APPENDIX 8.4
VISUAL IMPACT ASSESSMENT

RE: Homebase, Syon Lane, Brentford TW8 - Approach to the TVIA views

REPRESENTATIVE VIEW SELECTION NOTE

Prepared by Katy Neaves
File Ref: A247-NT02.5

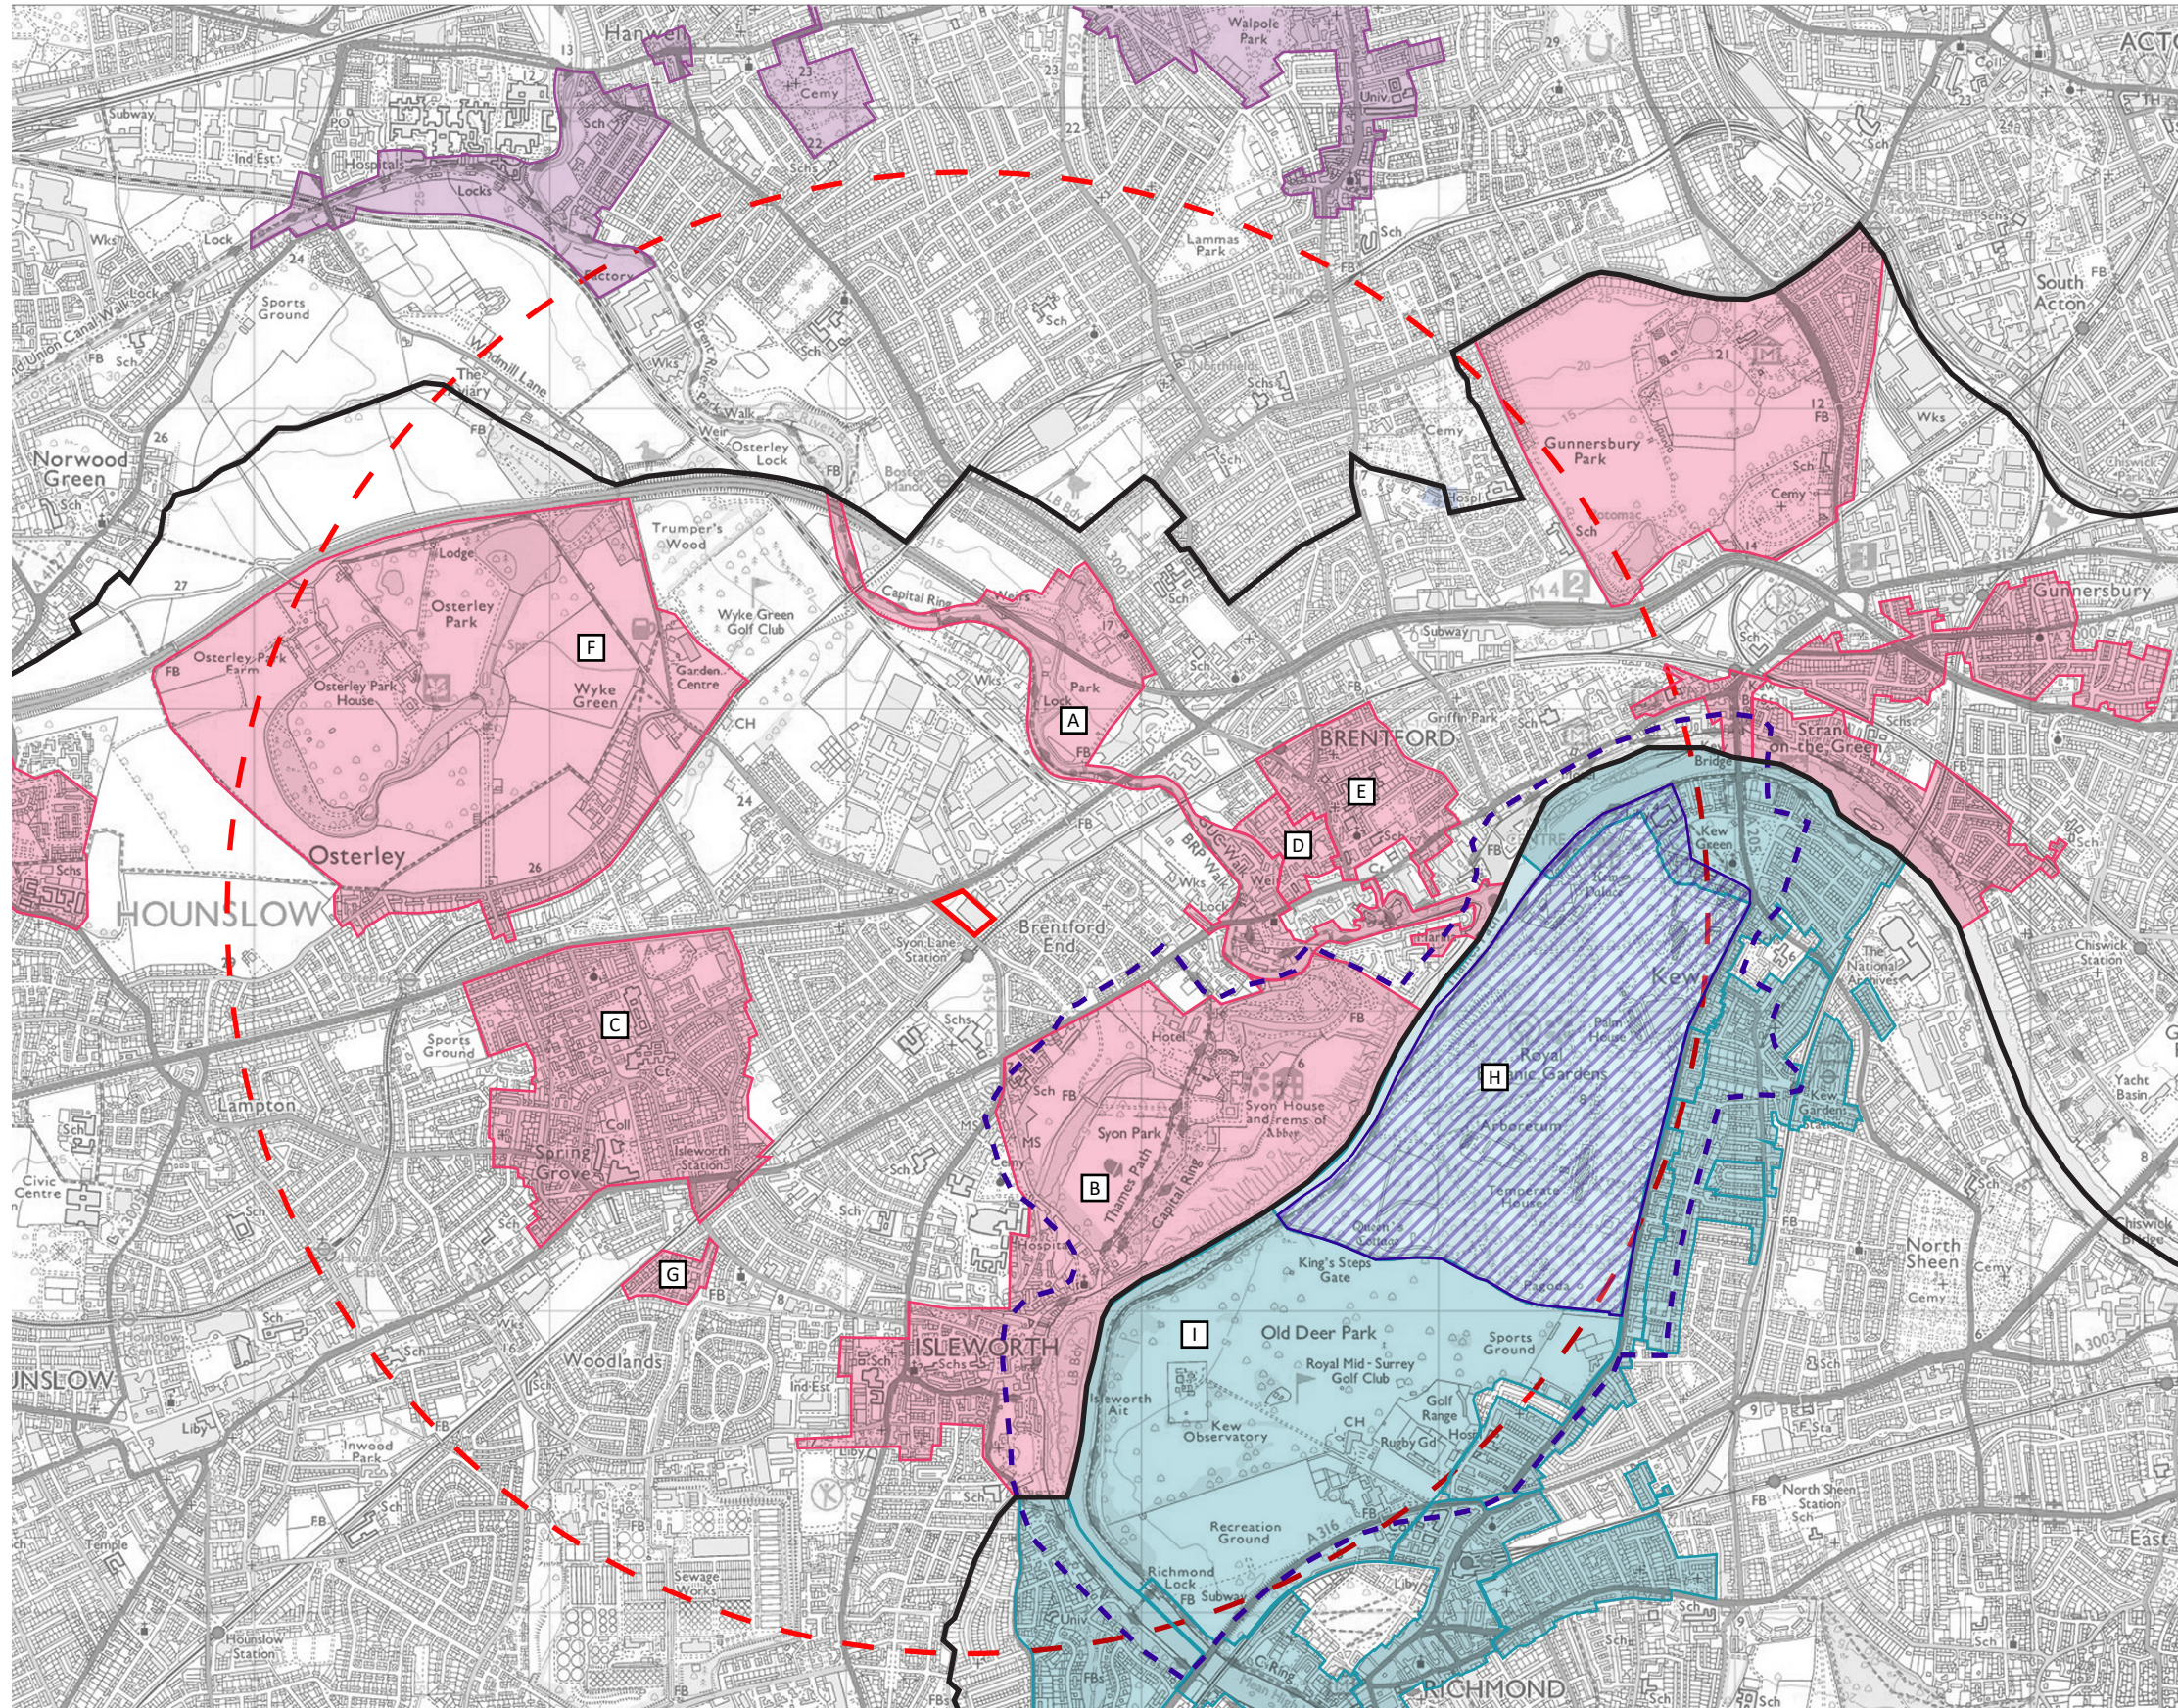
4. As part of the pre-application consultation process we have sought comments on the location of the representative views from LBH. This has led to the request to not test the view from Gunnersbury Cemetery, as LBH consider that this view is not necessary and is unlikely to show any impact, and review potential view from:

- Gunnersbury Park, to the north east of the Bowling Club Pavilion; and,
 - Junction of Great West Road and Jersey Road
5. At the time of undertaking the July 2019 field study it was not possible to capture a view from the Bowling Club Pavilion at Gunnersbury Park. This is due to the plant associated with the new Sports Facility currently under construction preventing views towards the Site. The main sports field in the centre of the park was also not publicly accessible, so views were reviewed from the parks northeast corner. Overall it was considered that the development's buildings, if visible, are likely to be read behind Great West House, 1000 Great West Road and GSK building and will have a limited effect. A view is therefore not proposed to be tested as part of the TVIA from the north east corner of Gunnersbury Park.

6. A view from the junction of the Great West Road and Jersey Road has been included from the central pedestrian crossing island as this will illustrate a long distance view to the Site from the west. The supporting **Figure 2** has been updated accordingly. We consider this an appropriate mix of views to demonstrate the visibility of the Site and the scheme proposal from the surrounding visual receptors.
